Nx25G-EPON Receive PCS

Motivation & assumptions

ONU Synchronization process (D1.2)

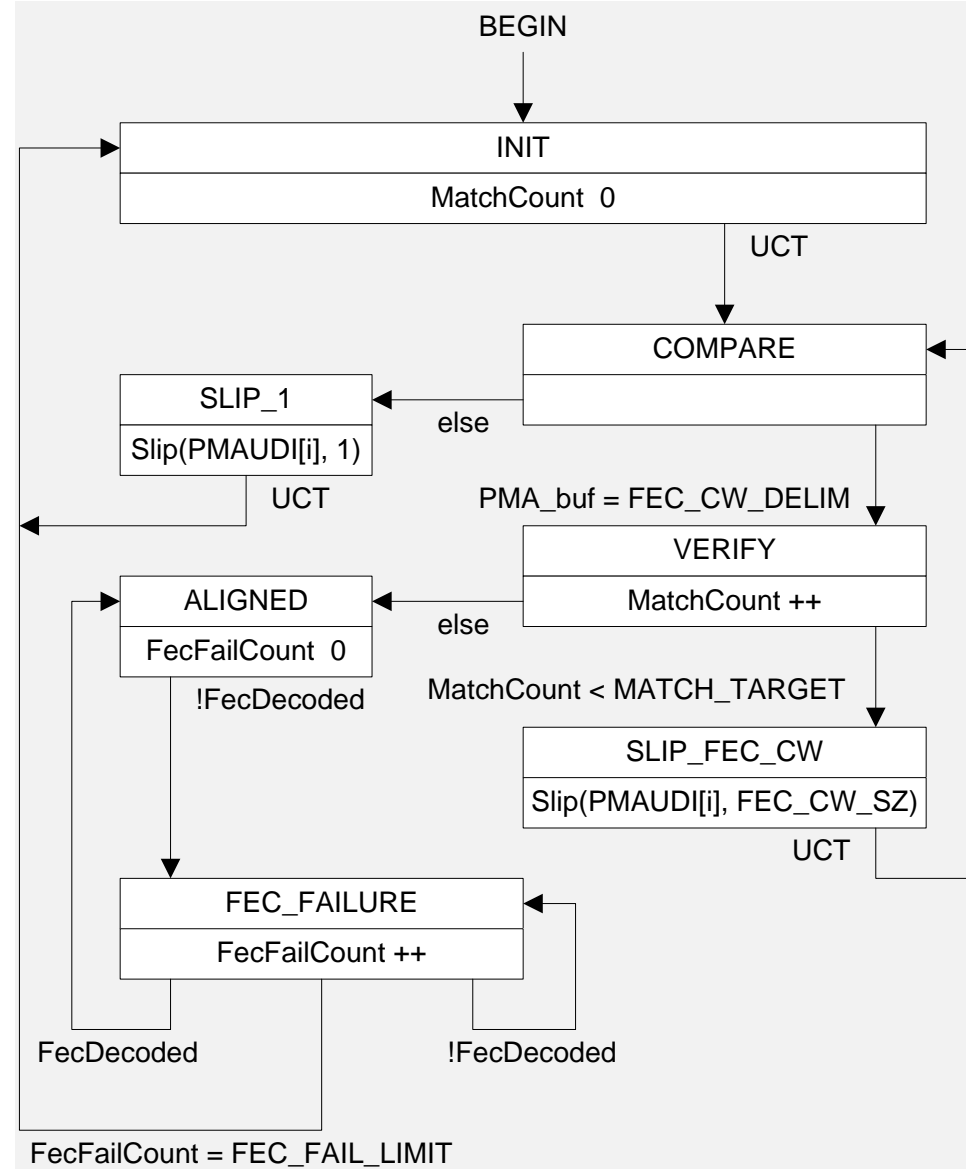
- Changed rx_buffer to PMAUDI[i] (alias for PMA_UNITDATA[i] <256:0>.indication)

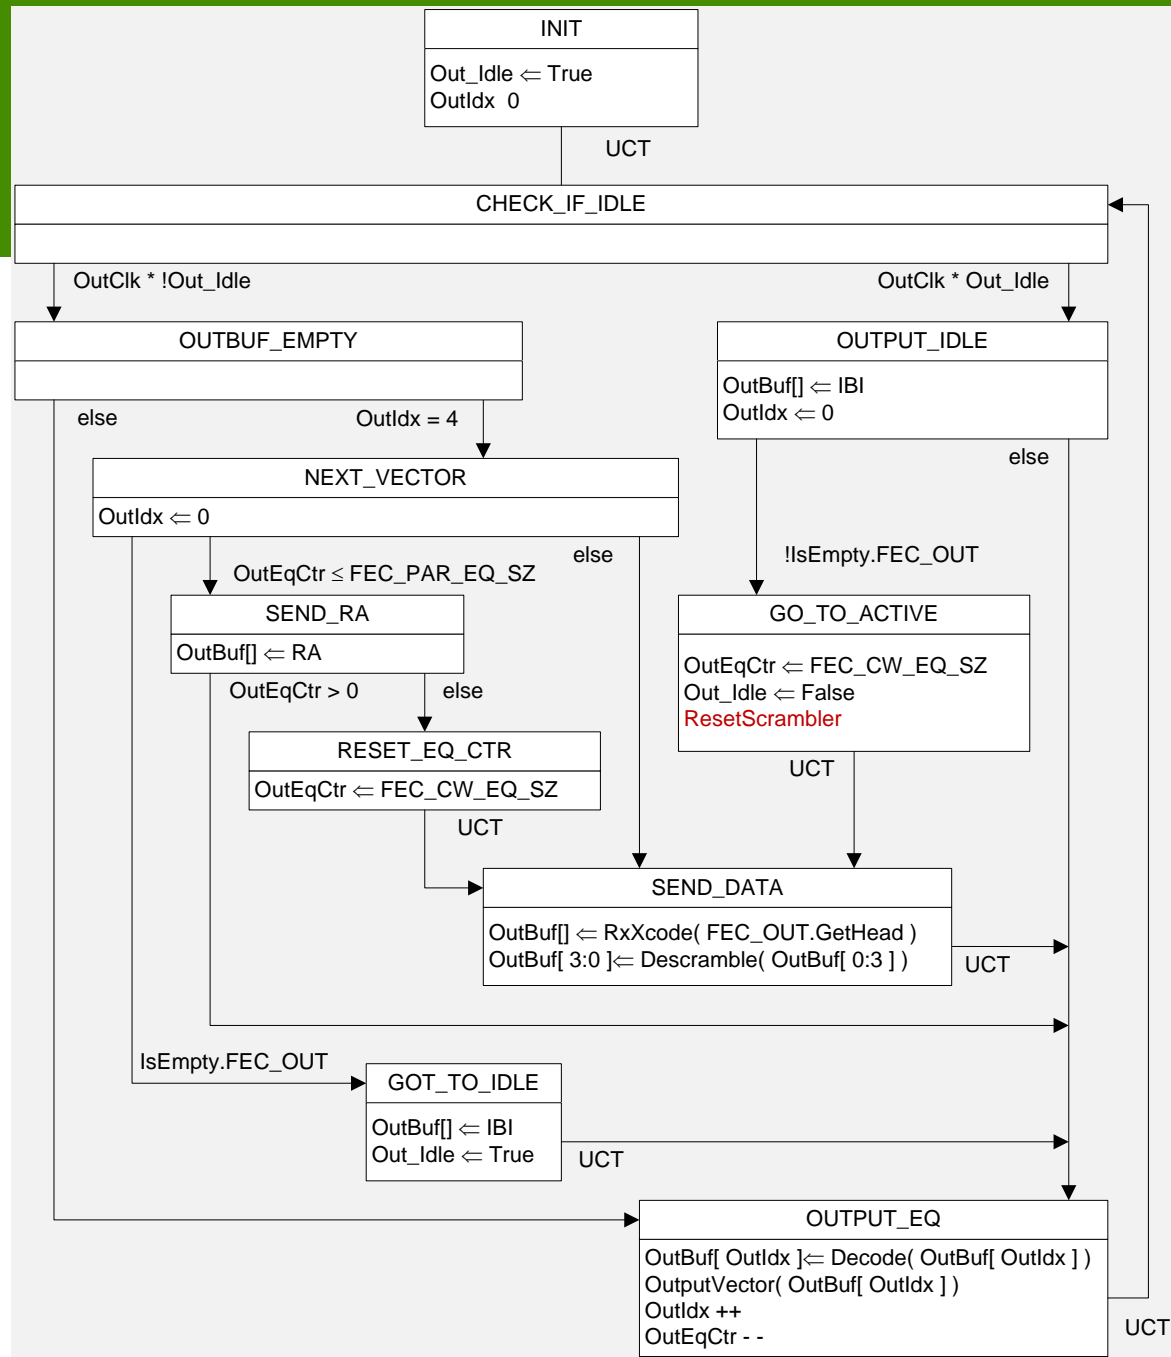
Add the following definition to Synchronizer variables removing rx_buffer.

PMASI[i]

Alias for PMA_SIGNAL[i].indication

PMAUDI[i]

Alias for

PMA_UNITDATA[i]<256:0>.indication

PCS FBD

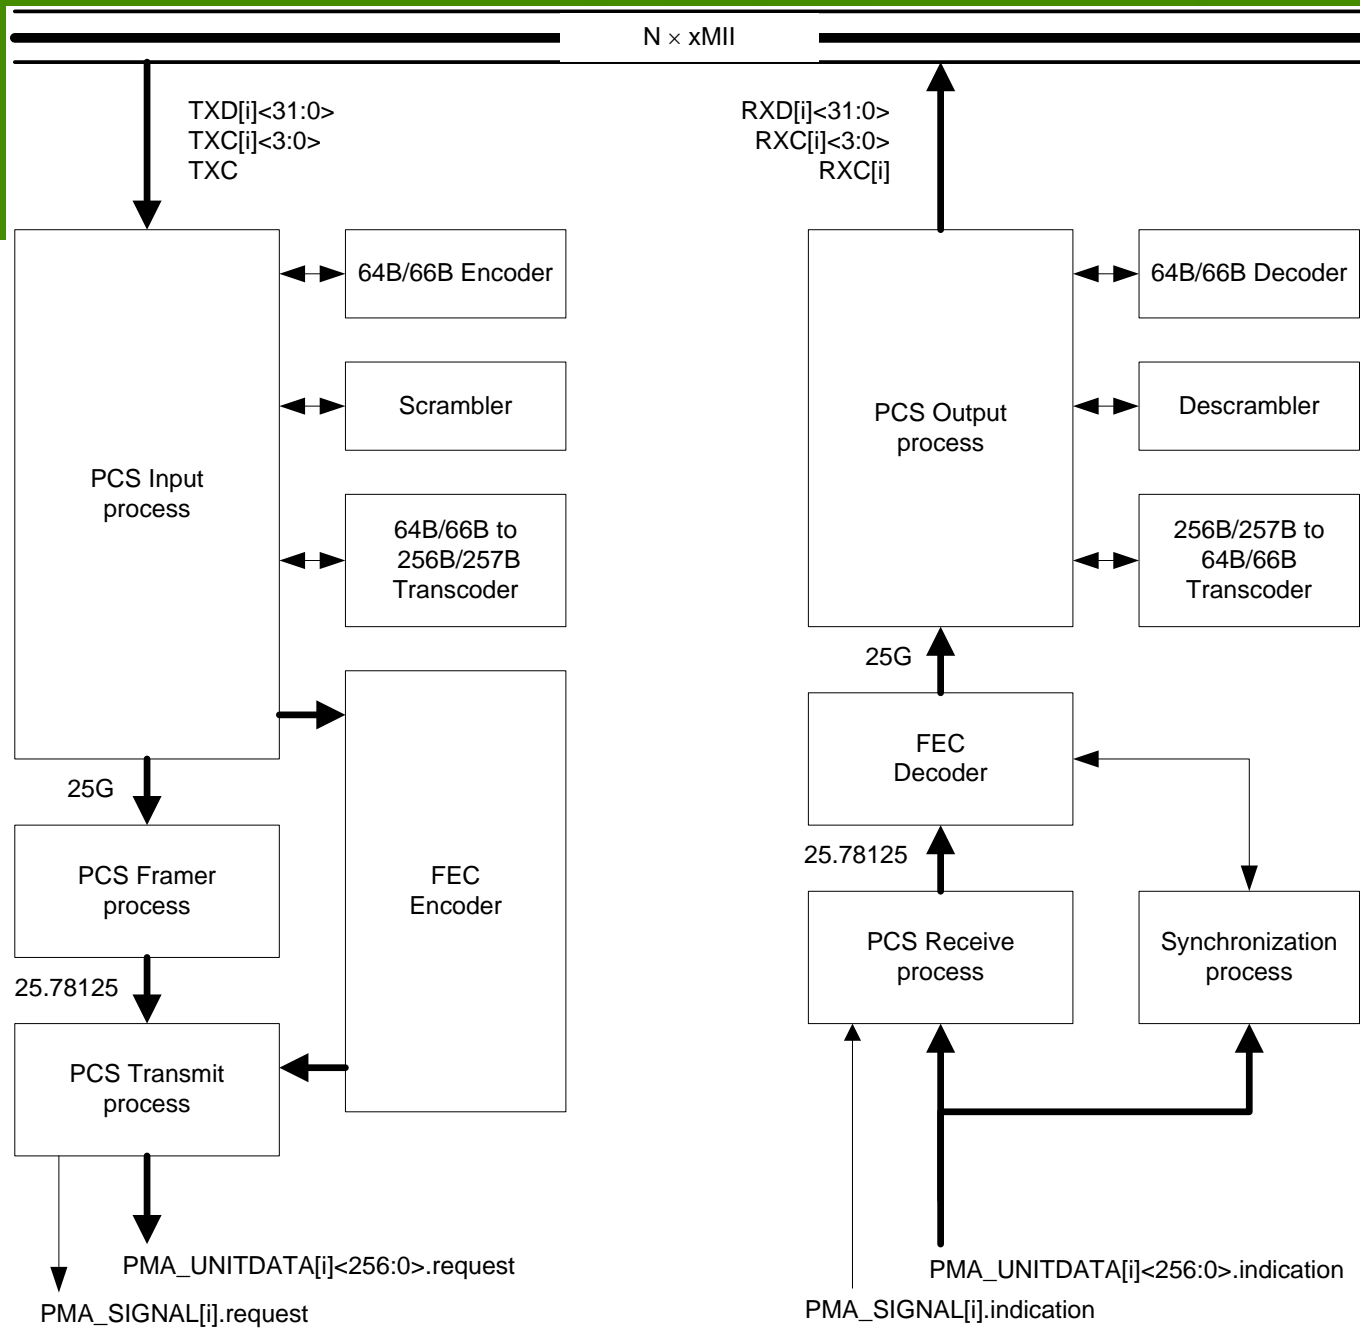
Update to
Figure 142-2

Omit 25G and
25.78125 from
this figure
